Access Compliance Report

Public Rights-of-Way

(Curb Ramps)

Intersection ID: 18977	Main Street: COLONY_RD	Cross Street: WHEELock_RD	Location: NE
ADA ID: 55880380E32B	Ramp Type: ParaDiag	Initial Pass/Fail: Pass	Overall Compliance: No
Severity Score: 0			
Codes/Mitigation Info/Possible Solution		Field Measurements/Component Compliance

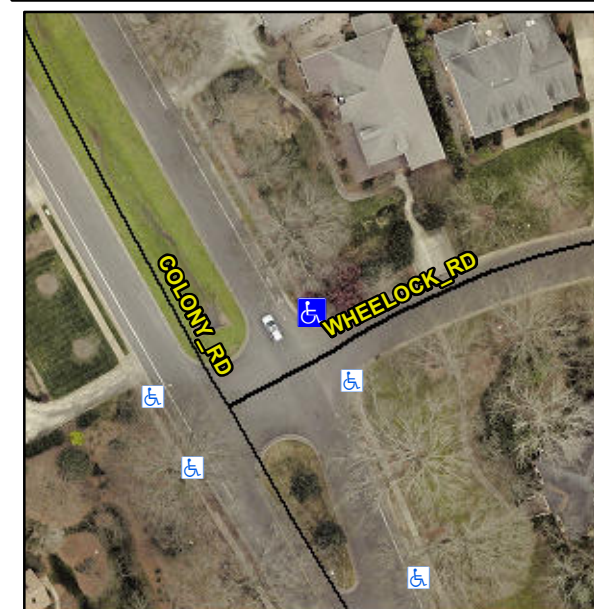
ASP LIP 0.5

Not Found, R304.2.1, R304.2.2-Perp, R304.3.2-Para

Remove & Replace Curb Ramp With Two New Directional Ramps or Equivalent.
